G. EVANS ; KENNINGTON, N.H.

TO: Kensington Planning Board
FROM: Chief Aquilina
REF: Driveway Proposal Review (Evans Property)

Re: Gloria Evans property, Kensington

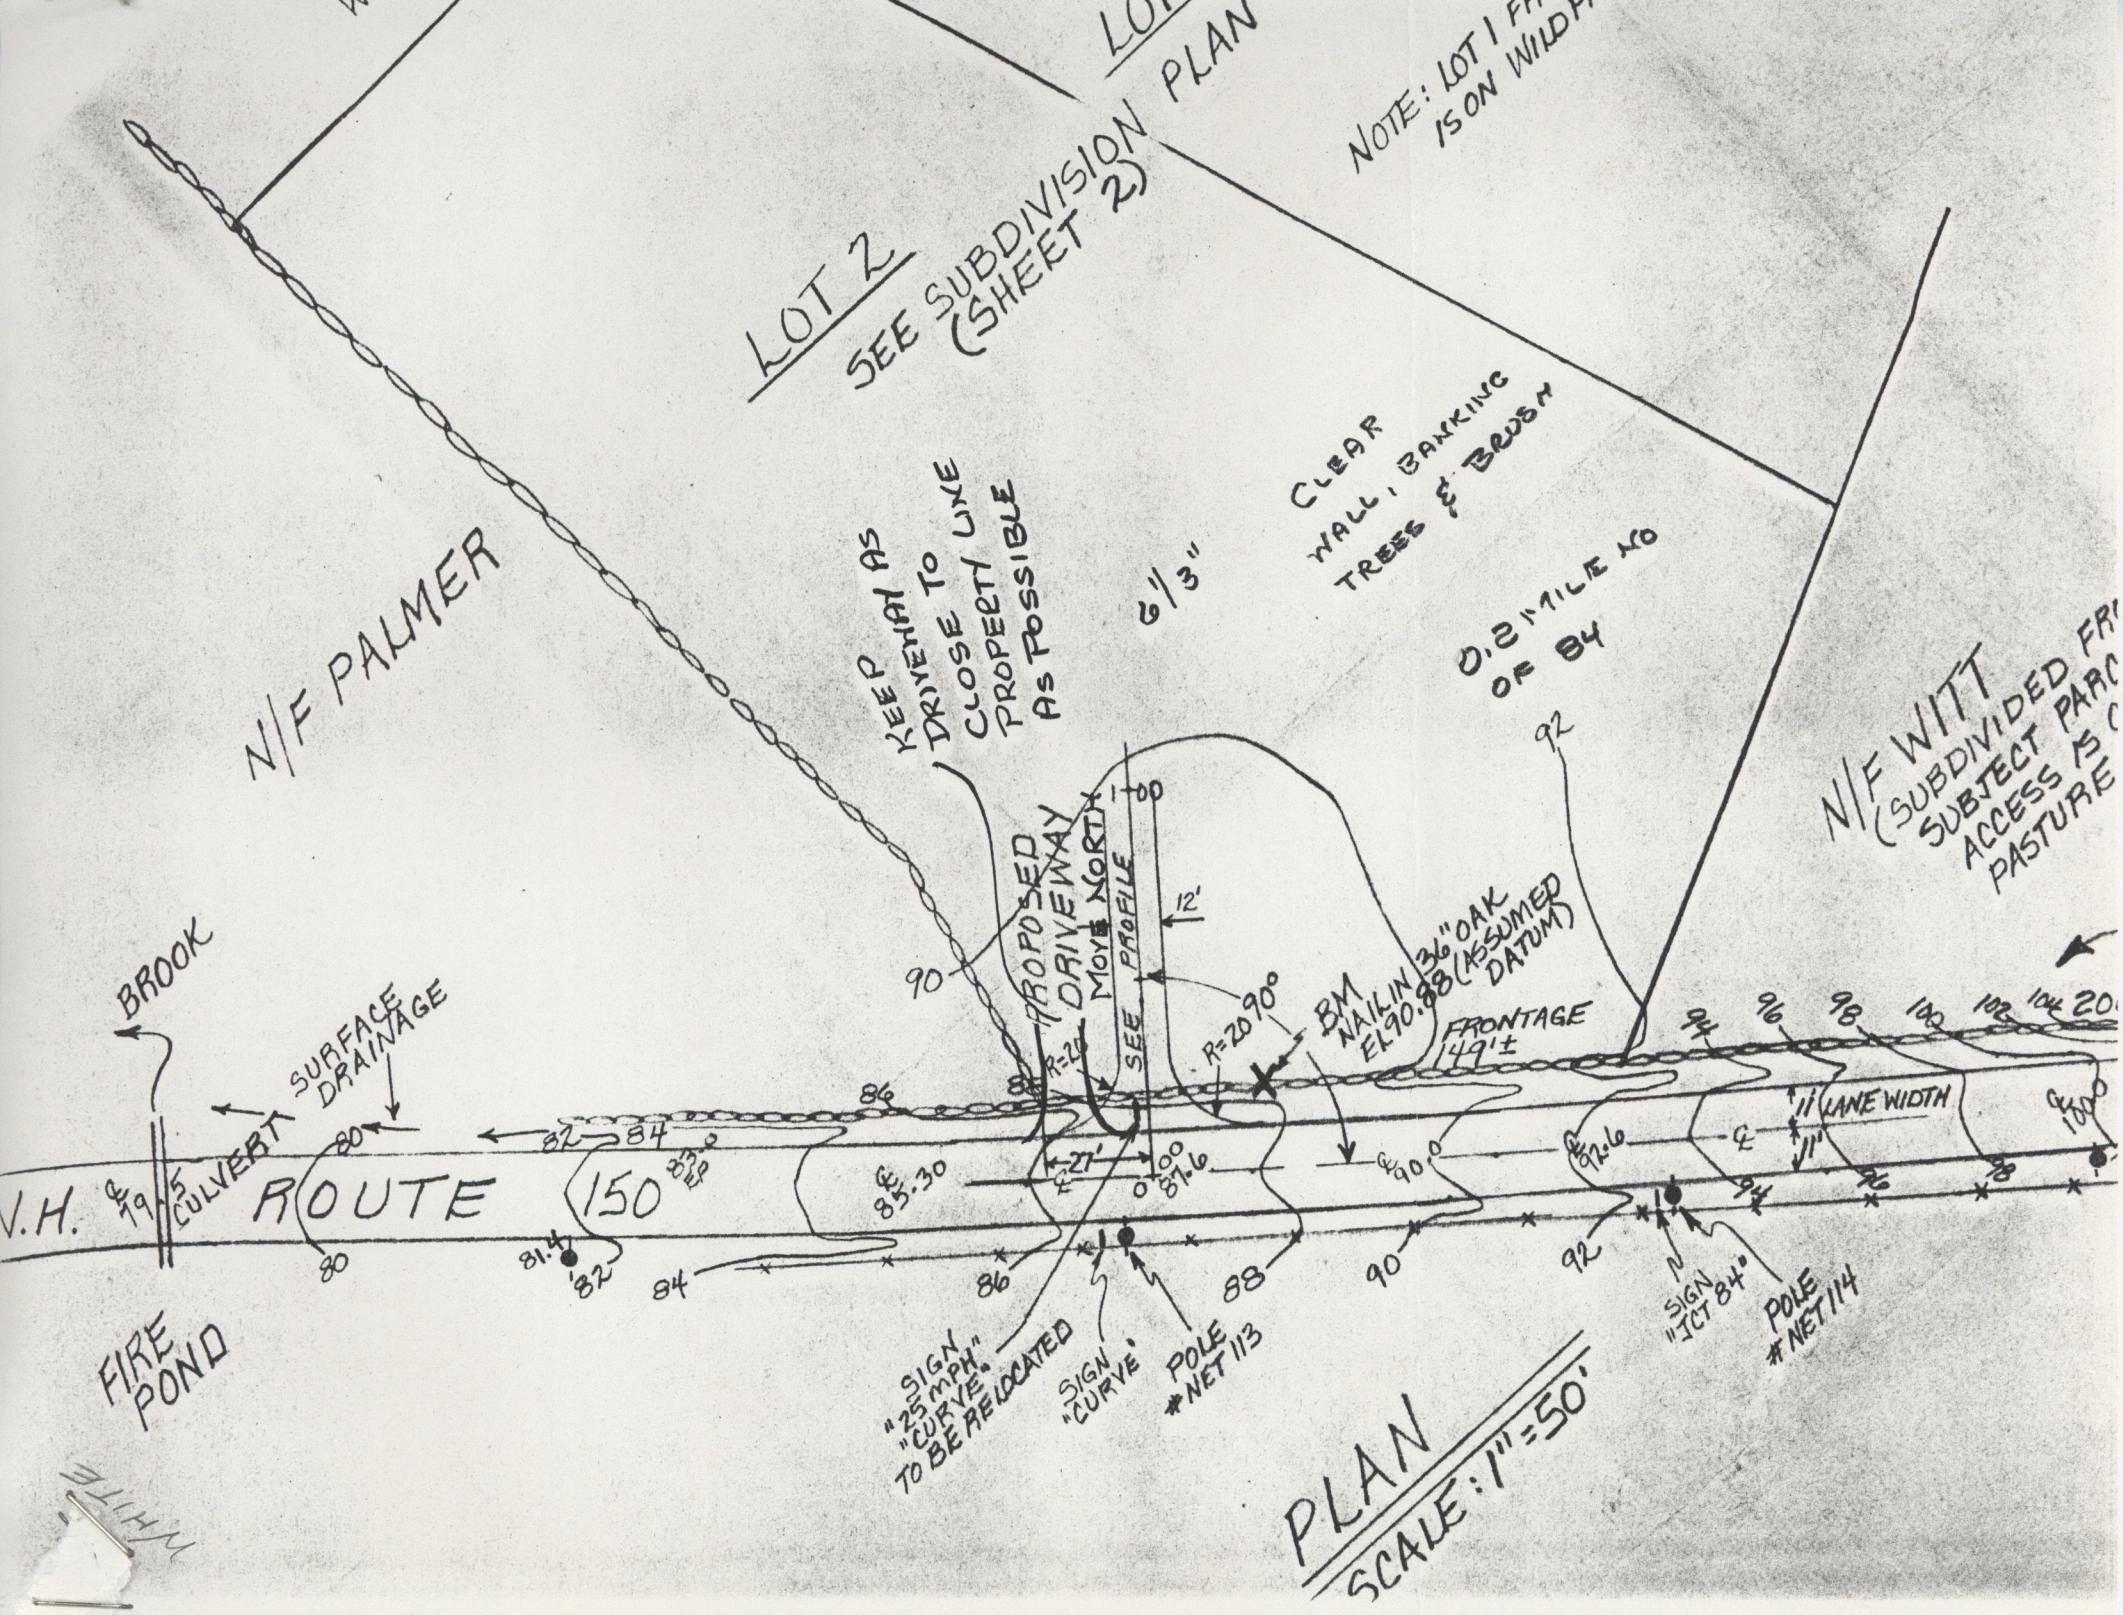
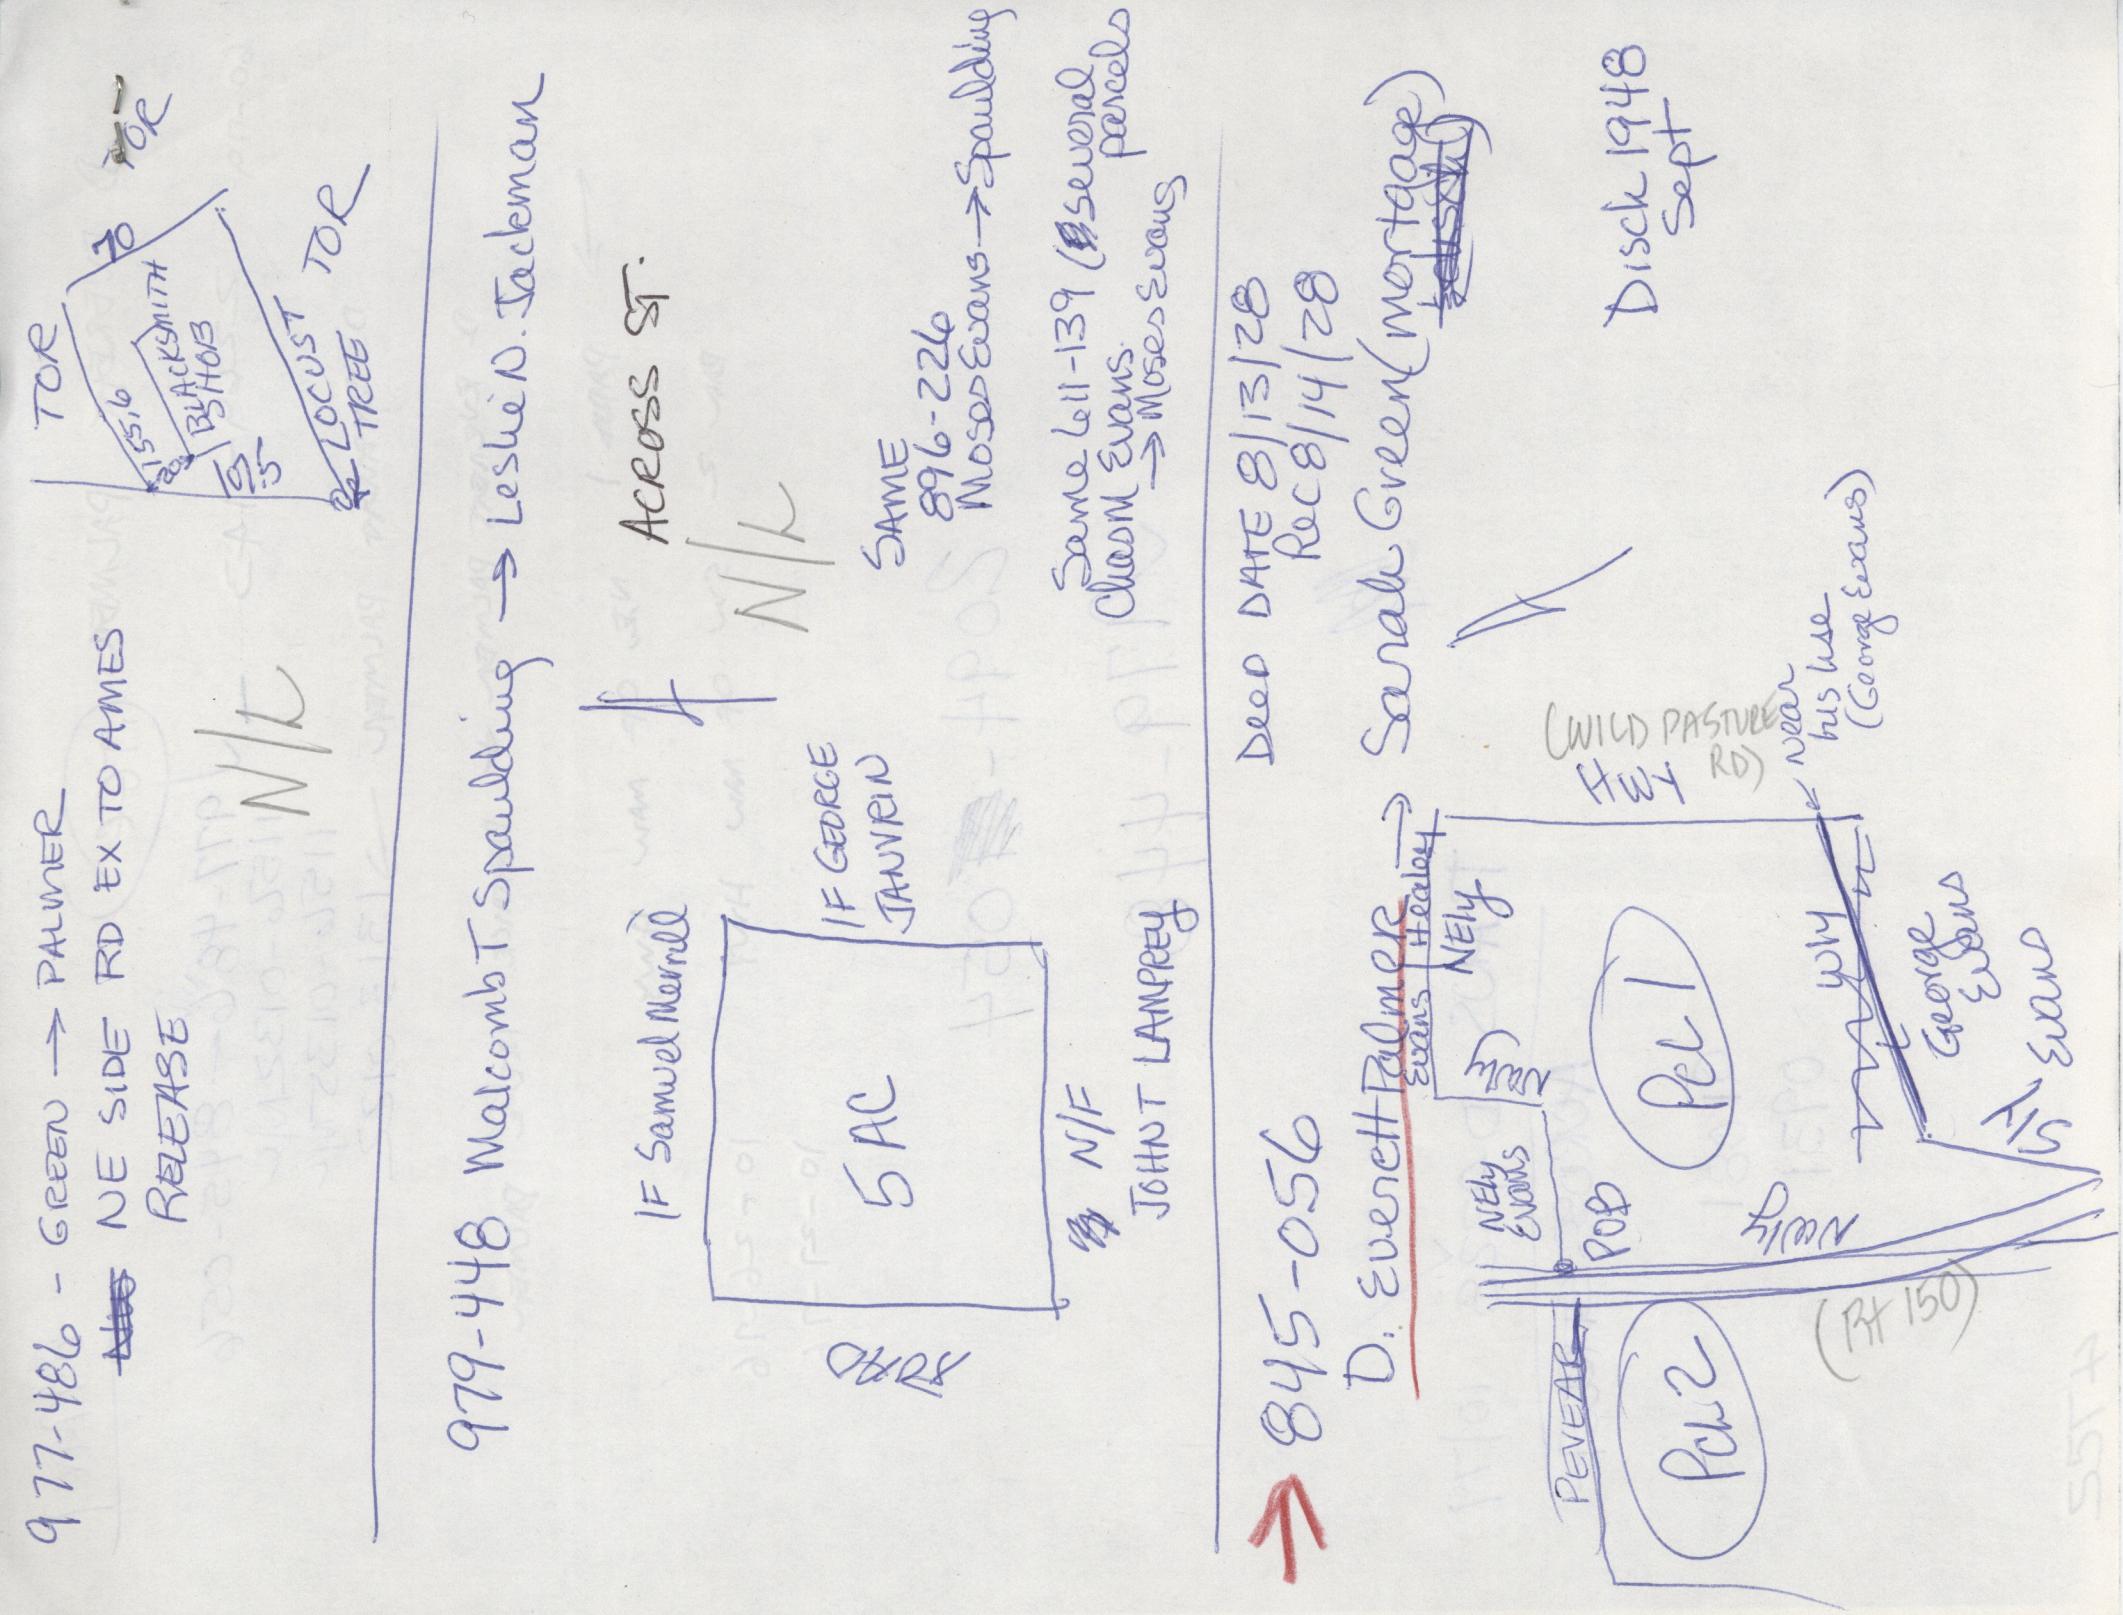
On the Lovell side the information on the working drawing did not provide an acceptable closure. I took a chance and resolved it as I thought best but of course am deferring to you for a decision. There are explanatory notes on my overlay and you can call me if it is not clear what I did.
